# SERVICE BULLETIN

B-080A

## 2007, 2008 and 2009 MODEL YEAR BUELL BLAST FUEL TANK RECALL

### Reason For Revision

**Figure 1. Existing Bracket**

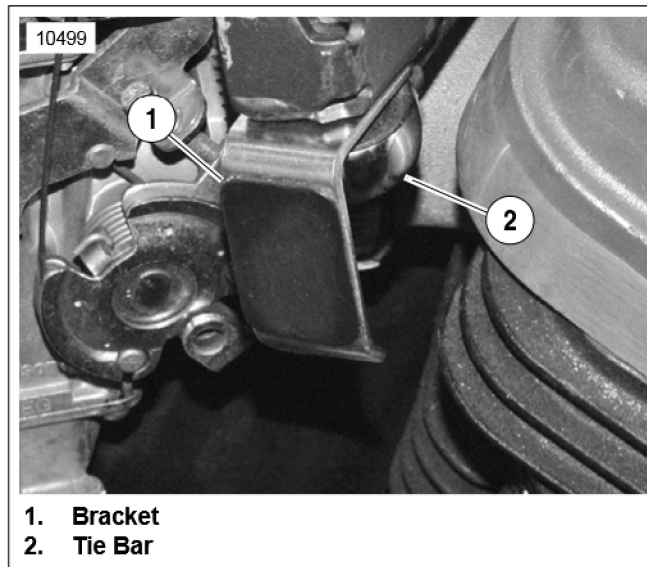
3. See Figure 1. Remove existing bracket (1) from tie bar (2). Discard old nut and retain screw for assembly.

**Figure 2. Install and Align New Bracket**

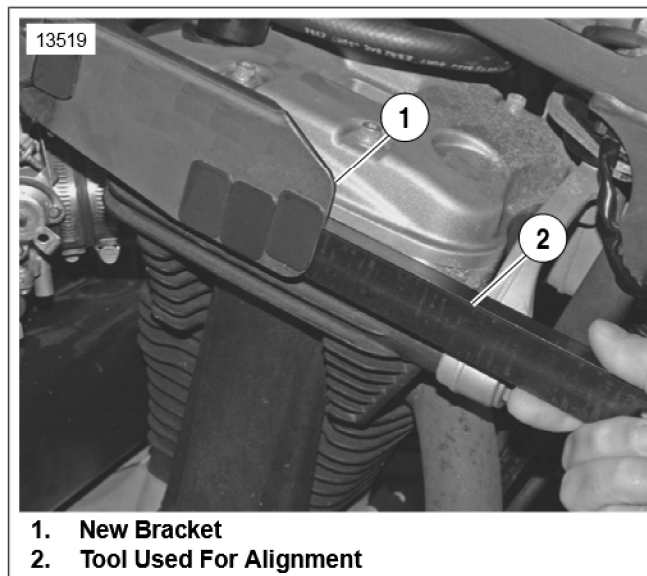
- See Figure 2. Using screw retained during removal process, **new** locknut, and Shift Lever Substitute Tool (HD-45338) (2) to provide 0.5 in. (12.7mm) clearance between fuel tank and cylinder head, install **new** bracket (1) provided in kit.

Figure 3. Bracket Properly Seated

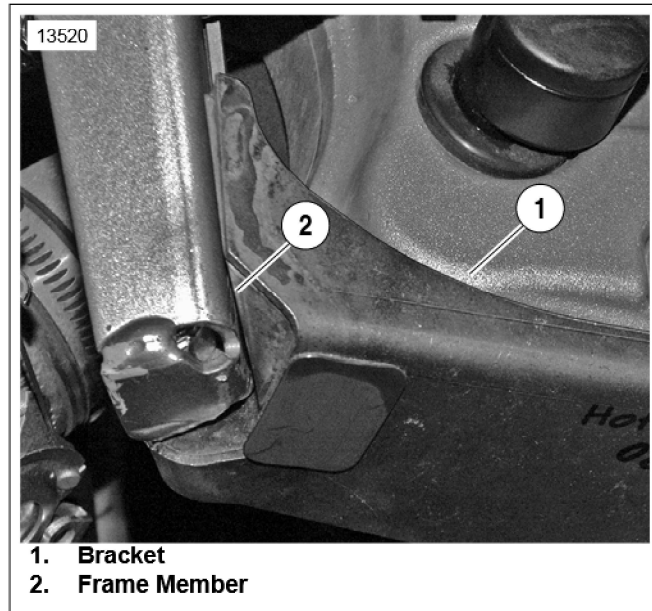
- See Figure 3. Verify back of bracket (1) is properly seated against frame member (2) as shown.
- Hold Shift Lever Substitute Tool in place and tighten bracket screw to 30-33 ft-lbs (41-45 Nm). Remove tool after tightening screw.

Figure 4. Fuel Tank Insulation

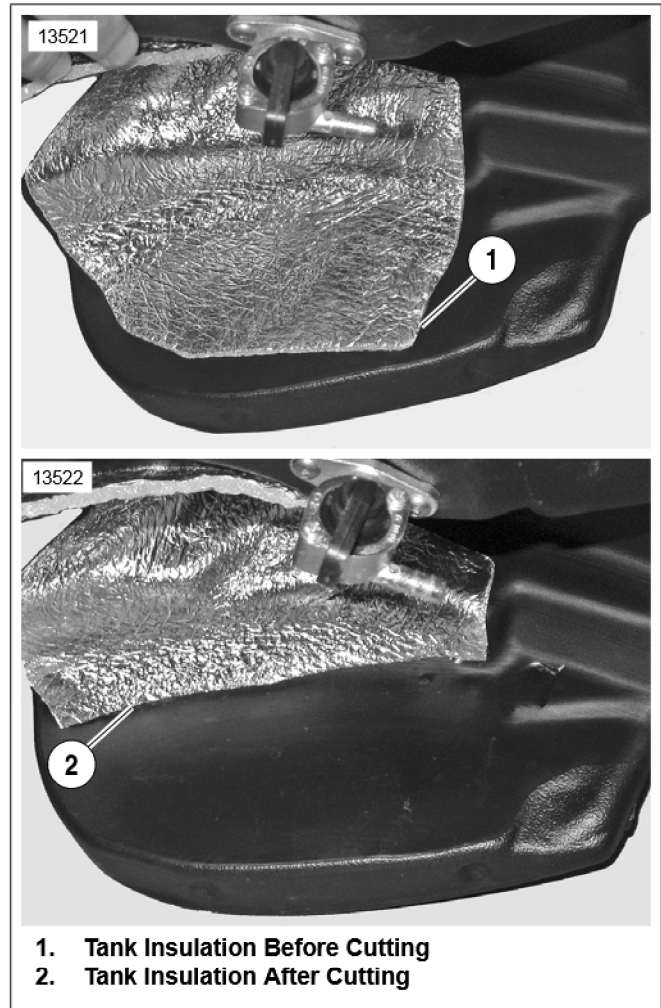
- See Figure 4. Trim existing tank insulation to provide proper clearance to **new** bracket.
- Install fuel tank and fuel tank cover per procedure in appropriate year and model service manual, using **new** wire tie and clamp provided in kit.
- Install main fuse.
